Form 3160-5
(June 2019)UNITED STATES
DEPARTMENT OF THE INTERIOR
BUREAU OF LAND MANAGEMENTFORM APPROVED
OMB No. 1004-0137
Expires: October 31, 2021**SUNDRY NOTICES AND REPORTS ON WELLS**
Do not use this form for proposals to drill or to re-enter an abandoned well. Use Form 3160-3 (APD) for such proposals.

8. Well Name and No. BRUSHY DRAW 30 FEDERAL/7011

**Spacing, Casing/Cement, Drilling Variance Changes

XTO Permian Operating, LLC requests permission to make the following changes to the original APD:

WELL LOCATION AND ACREAGE DEDICATION PLAT

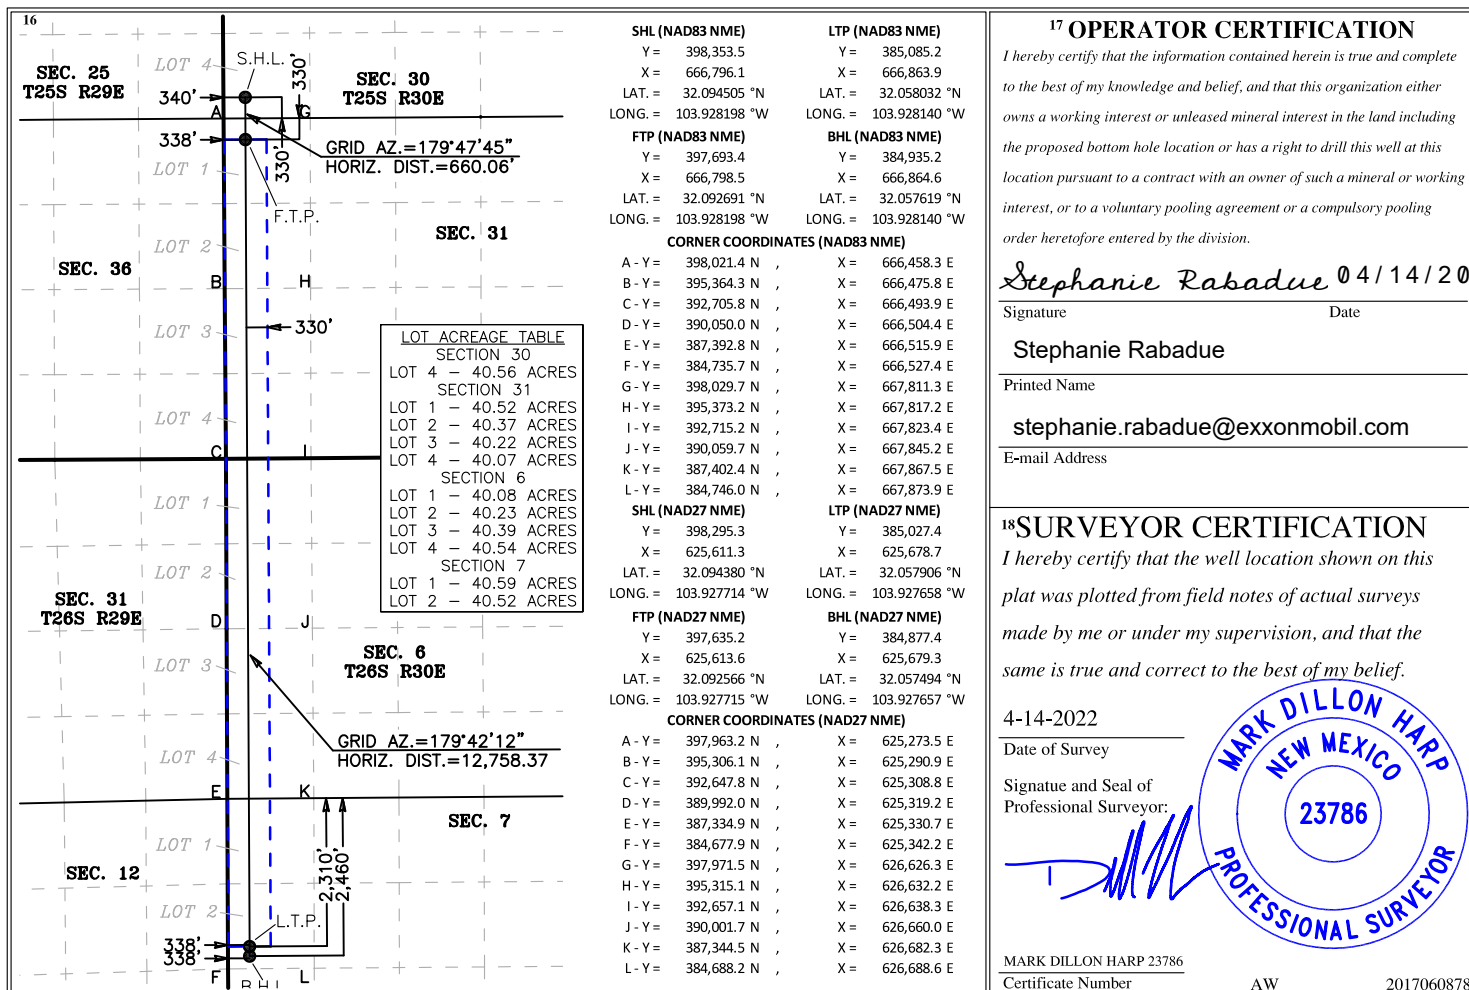
Change BHL fr/2440FNL & 330FWL to 2460FNL & 338FWL

UL or lot no.	Section	Township	Range	Lot Idn	Feet from the	North/South line	Feet from the	East/West line	County
2	7	26 S	30 E		2,460	NORTH	338	WEST	EDDY

Note: Picture below highlights BOP components that will be tested during batch operations

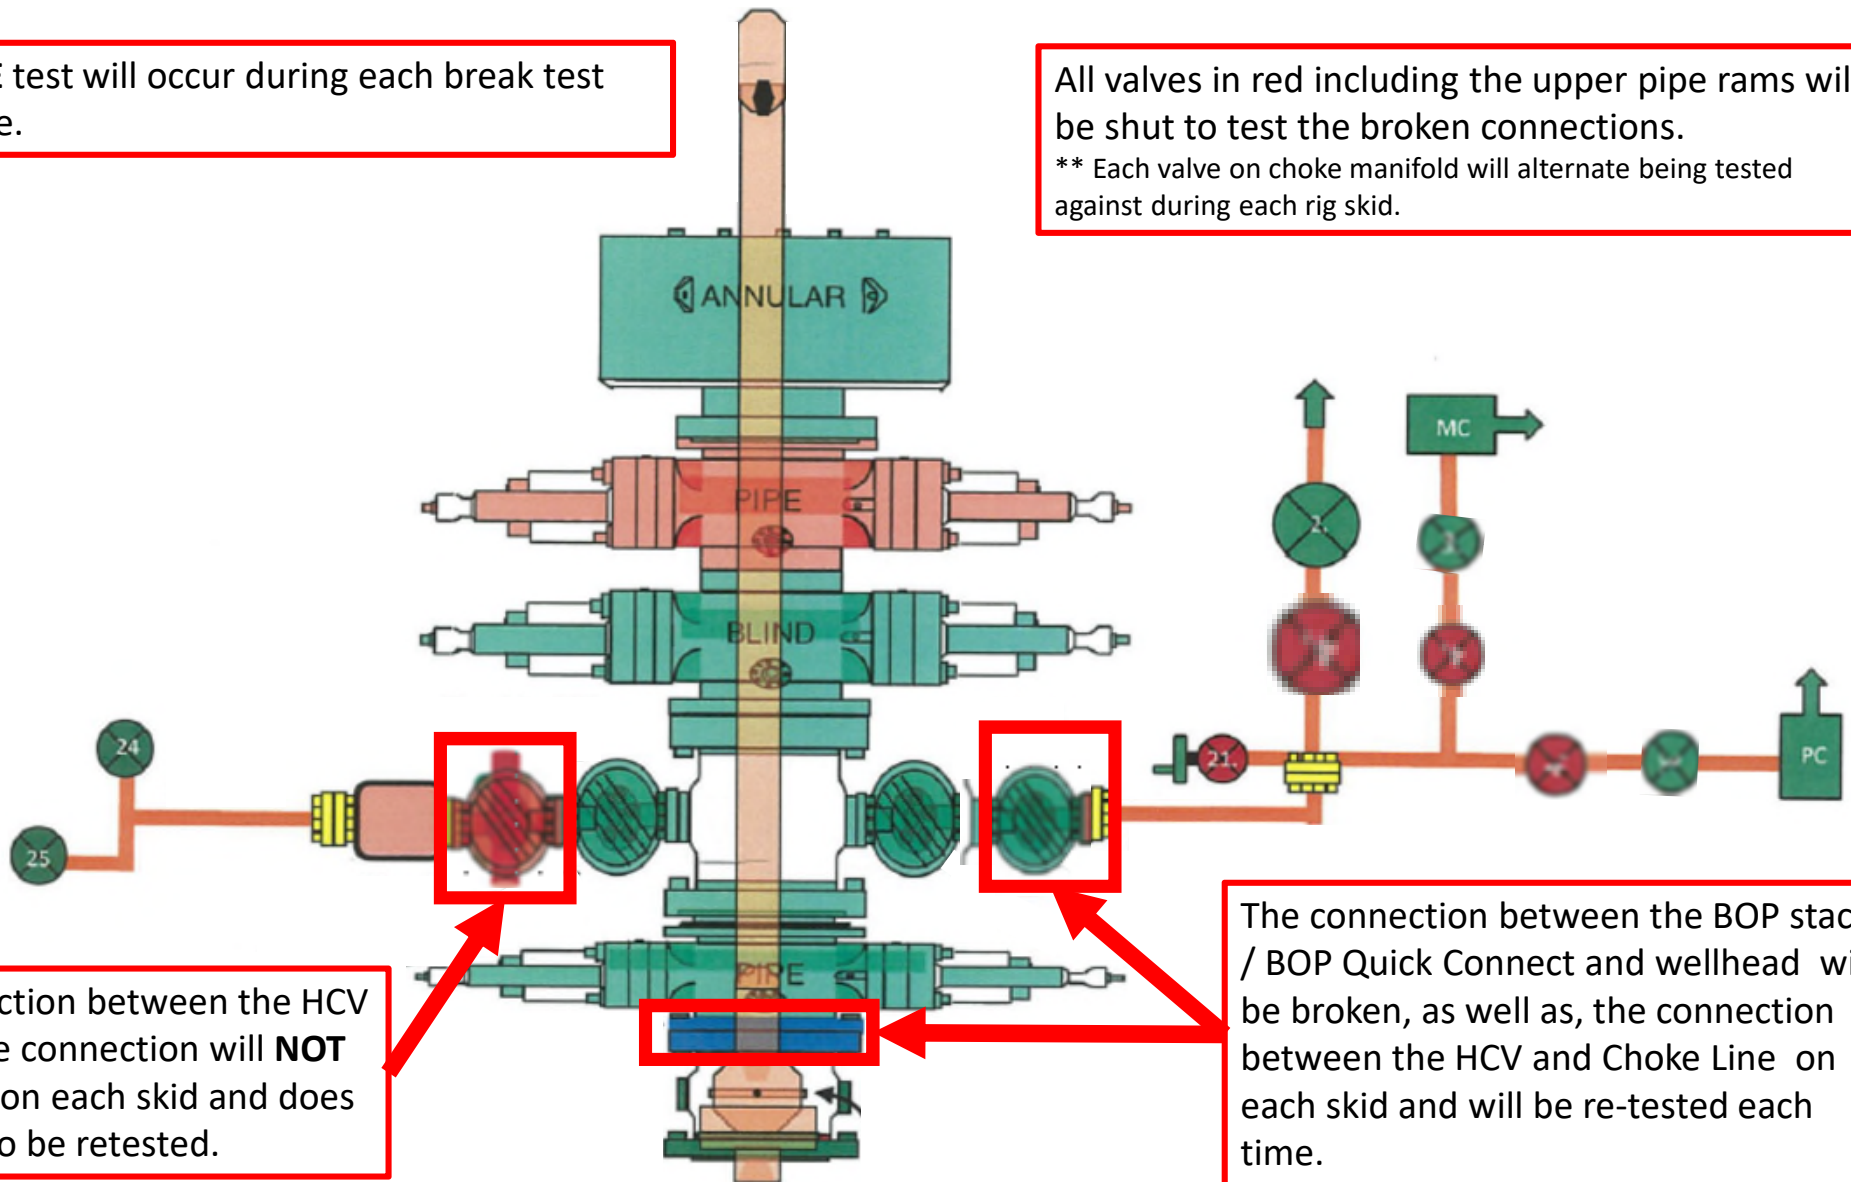
All valves in red including the upper pipe rams will be shut to test the broken connections.

** Each valve on choke manifold will alternate being tested against during each rig skid.

The connection between the HCV and kill line connection will **NOT** be broken on each skid and does not need to be retested.

The connection between the BOP stack / BOP Quick Connect and wellhead will be broken, as well as, the connection between the HCV and Choke Line on each skid and will be re-tested each time.
